**PRYOR PUBLIC SCHOOLS
PRYOR JR HIGH SHELTER
ADDITION**

a
d
d
e
n
d
u
m

n
o
.
t
w
o

addendum number: TWO (2)
date: 10.18.2019
project: PRYOR PUBLIC SCHOOLS
Junior High Shelter Addition
PRYOR, OK
project number: 1803
architect: The Stacy Group
8091 N. Owasso Expressway
Owasso, OK 74055
(918) 272-2622
f (918) 272-2633

E201

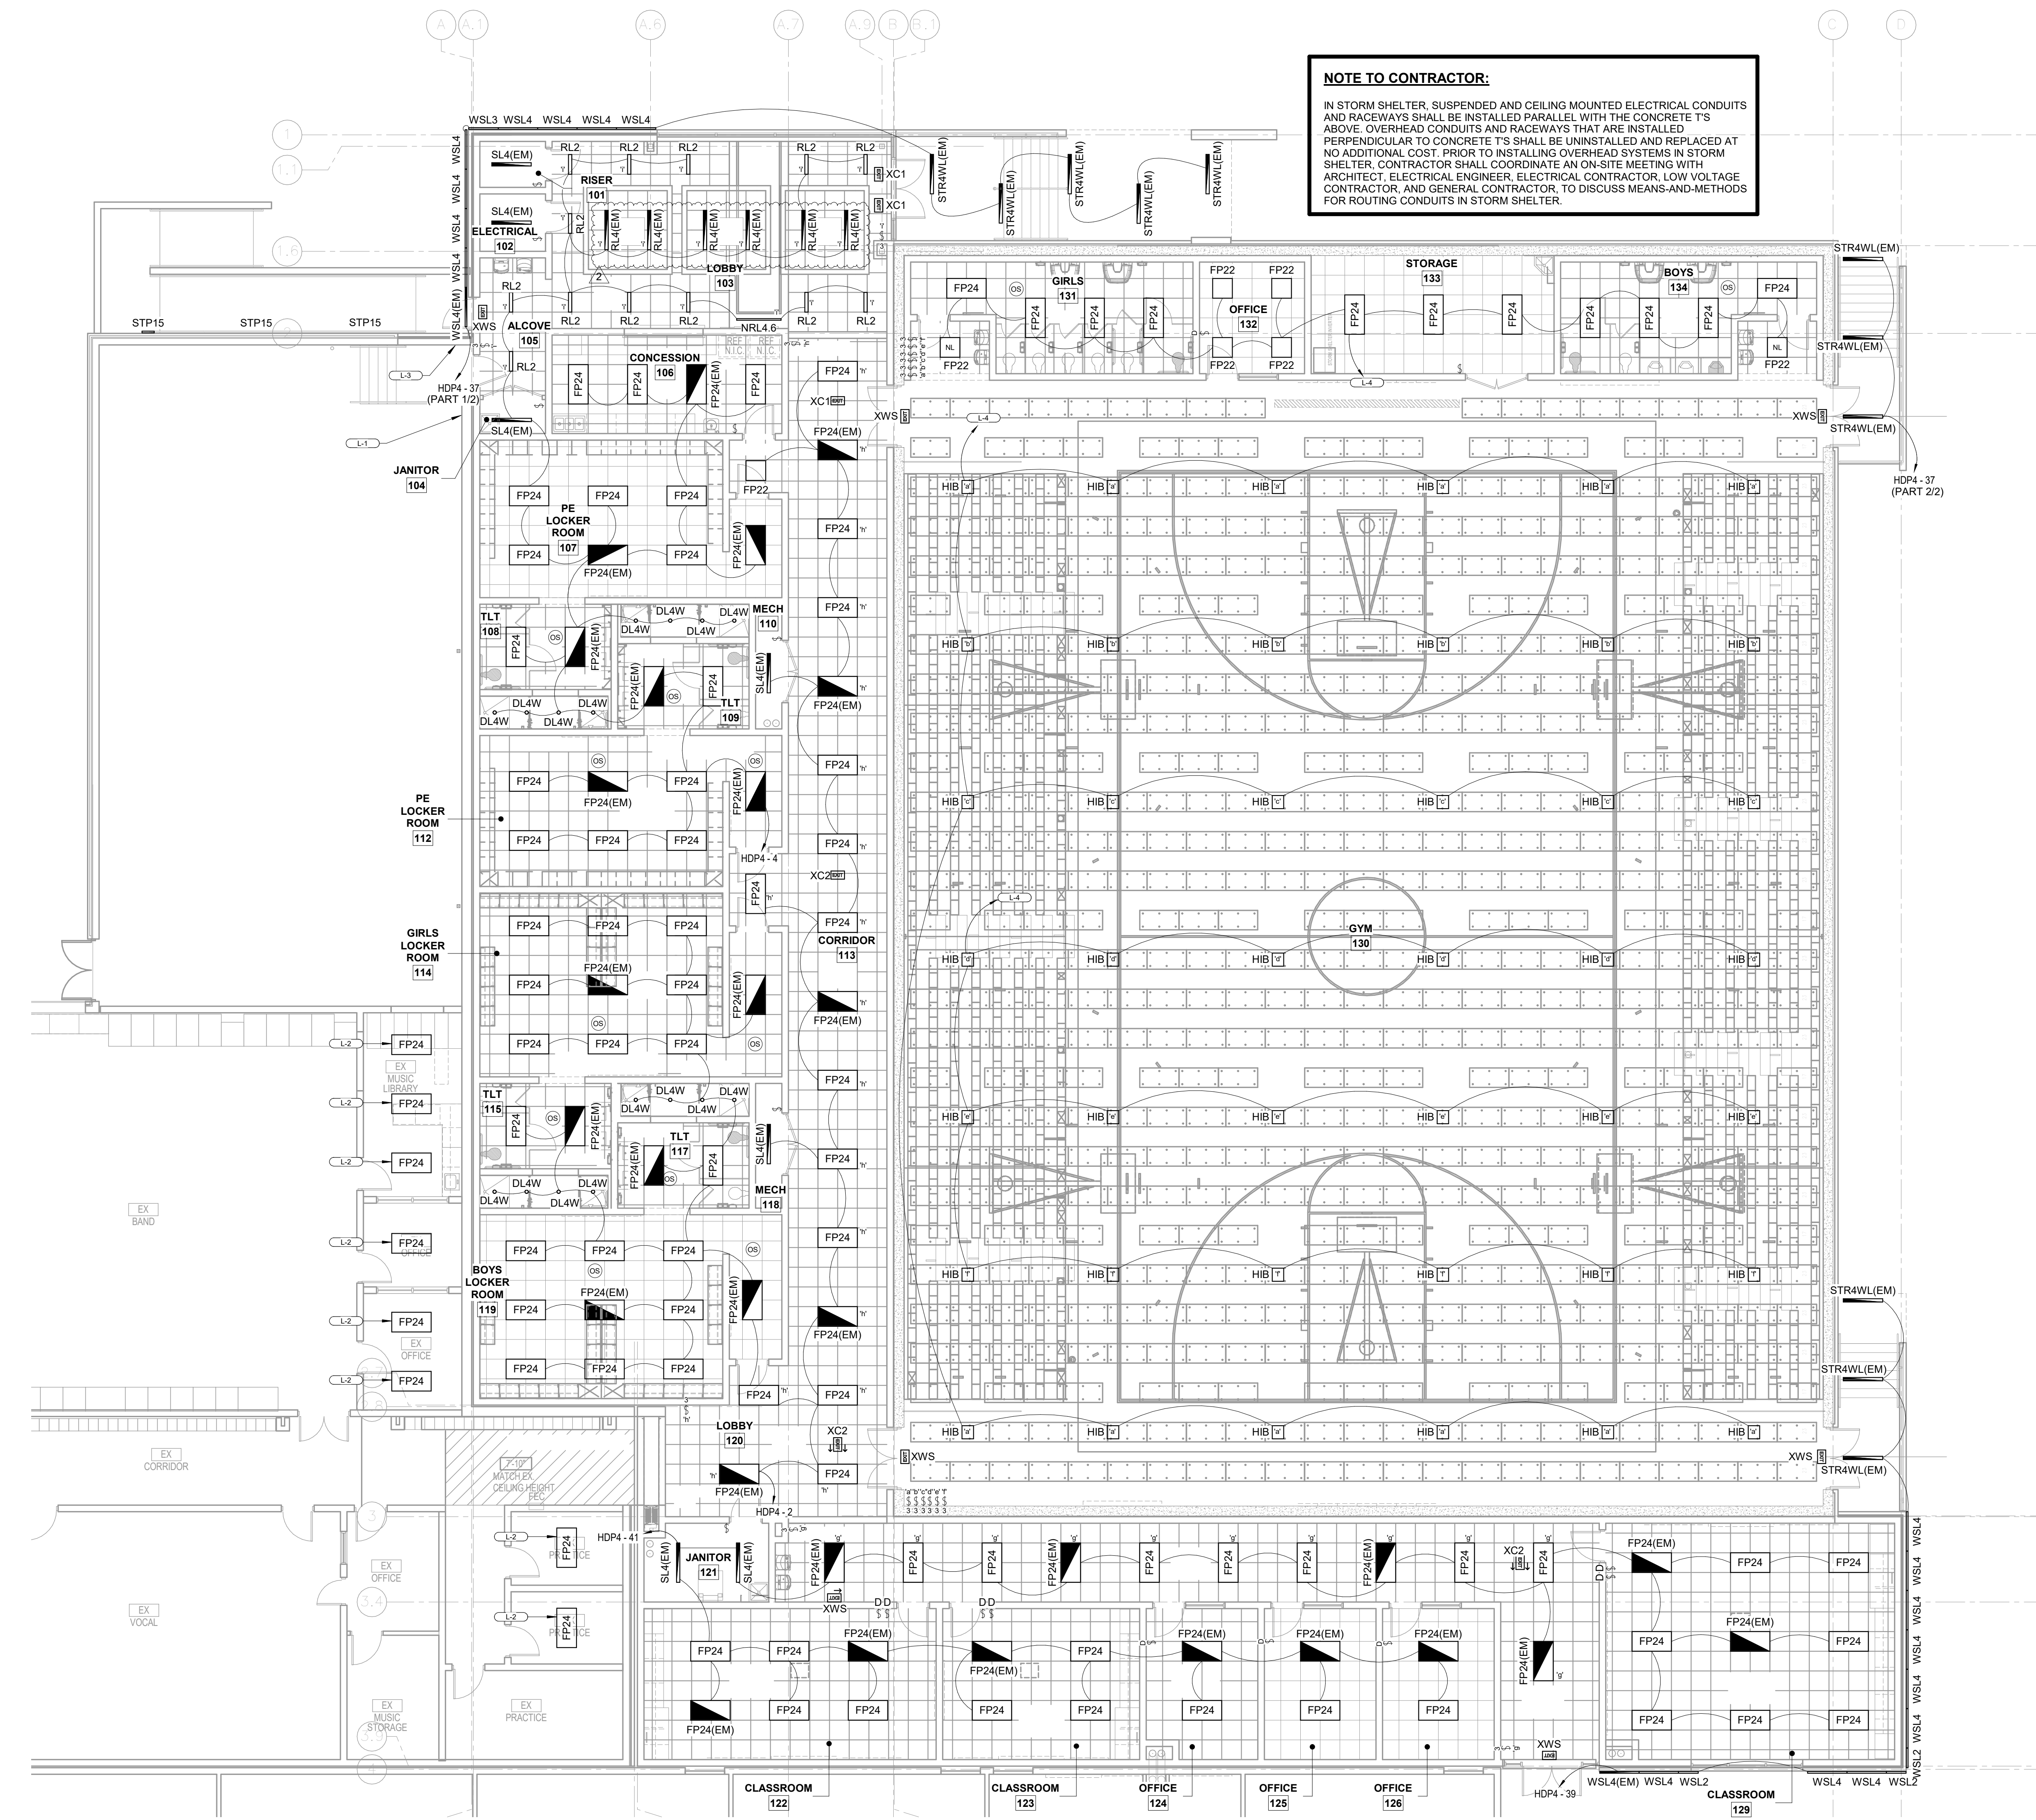
- A2-13 **Sheet E201 Lighting Plan:** Revise emergency lighting requirements in Lobby 103.
- A2-14 **Sheet E501 Fire Alarm Plan:** Add exterior horn strobe on exterior of riser room to identify FDC. Add note requiring monitor modules w/ a visual indicator for each tamper switch.

E600

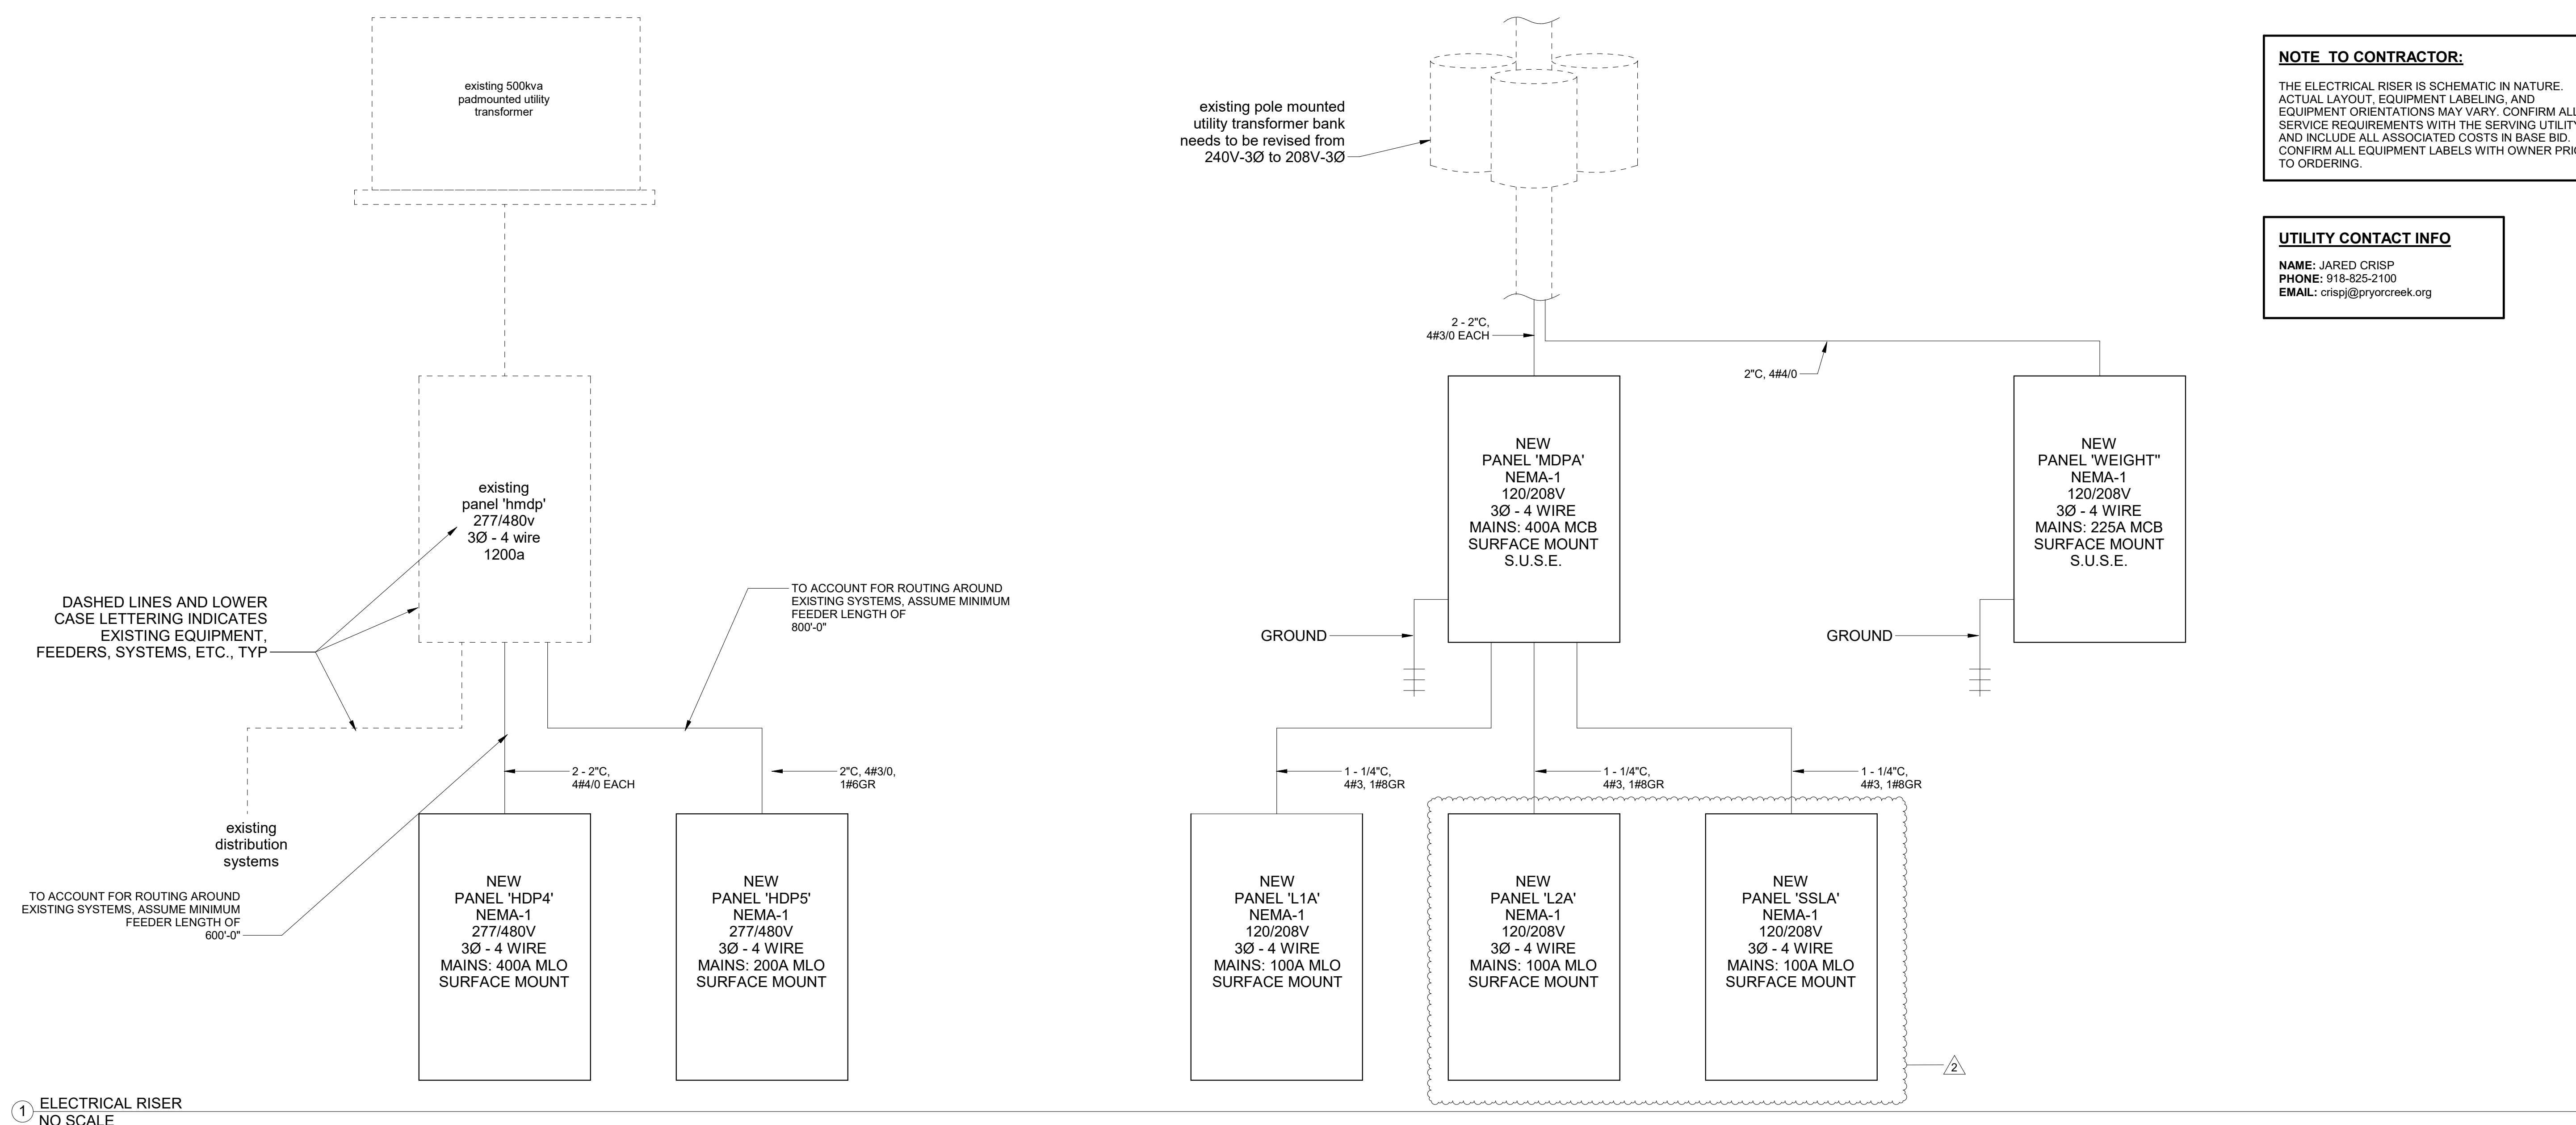
A2-15 Sheet E600 Electrical Riser and Schedules: Revise light fixture schedule, ref clouded portions. Revise voltages for panels L2A and SSLA in electrical riser to match the voltages identified in their panel schedules.
